Re: Turkey Point Units 3 and 4
Docket Nos. 50-250 and 50-251
Supplemental Response to NRC Request for Additional Information Regarding
Extended Power Uprate License Amendment Request No. 205
and Containment and Ventilation Issues

RESPONSE TO NRC RAI REGARDING EPU LAR NO. 205
AND SCVB CONTAINMENT AND VENTILATION ISSUES

Figure 1: Turkey Point Units 3 and 4 Containment Pressure Comparison for DEPS MINSI (Double Ended Pump Suction, Minimum Safeguards) Case

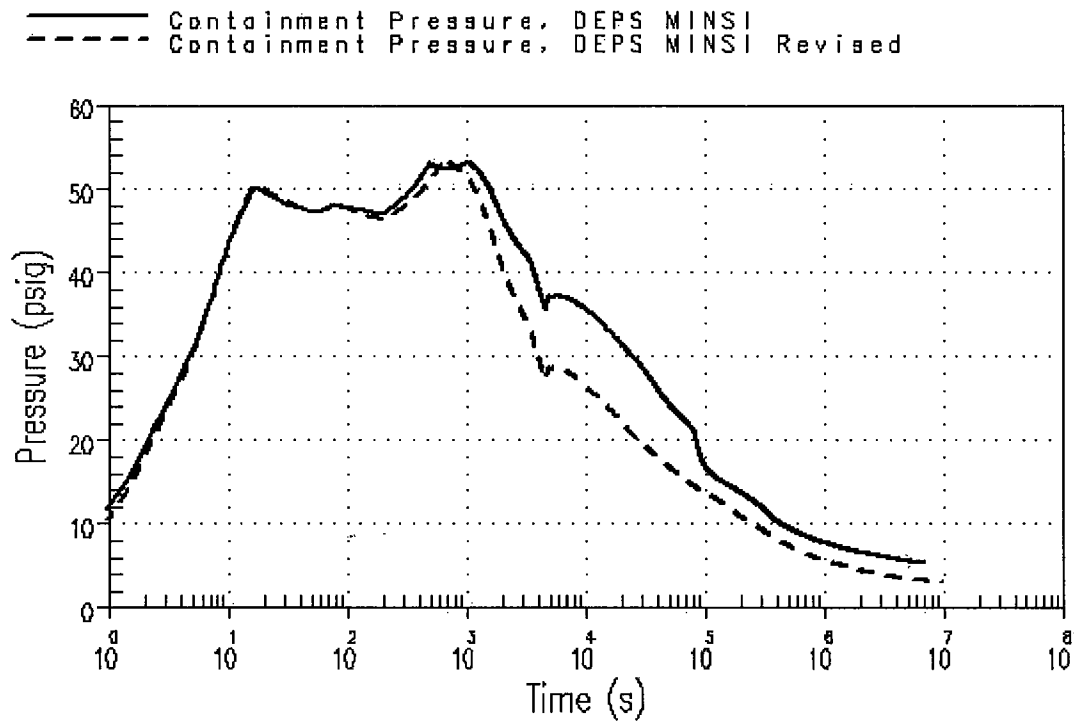
1. Peak LOCA containment vapor temperature increased by 3.0°F to 281.8°F (See Figure 2).
2. Peak LOCA containment pressure increased by 0.5 psi to 53.9 psig (See Figure 1). The design limit is 55 psig.

Figure 3: Turkey Point Units 3 and 4 Containment Pressure Comparison for the Limiting Pressure Case

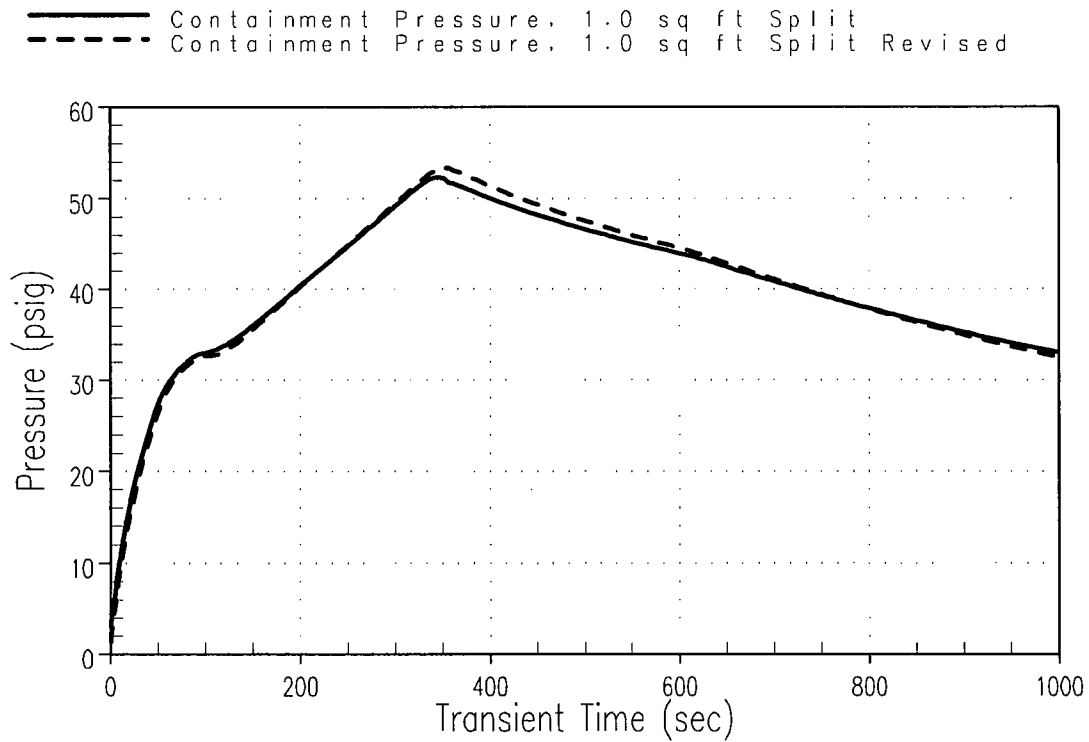
1. Peak SLB containment temperature increased by 14.5°F to 317.0°F (See Figure 4).
2. Peak SLB containment pressure increased by 1.1 psi to 53.4 psig (See Figure 3). The design limit is 55 psig.
3. Peak SLB structural temperature increased by 15.3°F to 279.2°F. The design limit is 283°F.
4. Maximum SLB component cooling water (CCW) heat exchanger inlet temperature (return) increased by 4.4°F to 179.7°F.
5. Maximum SLB CCW heat exchanger outlet temperature (supply) increased by 2.9°F to 151.8°F.
6. Maximum SLB emergency containment cooler (ECC) cooling water outlet temperature increased by 5.8 F to 202.1°F.
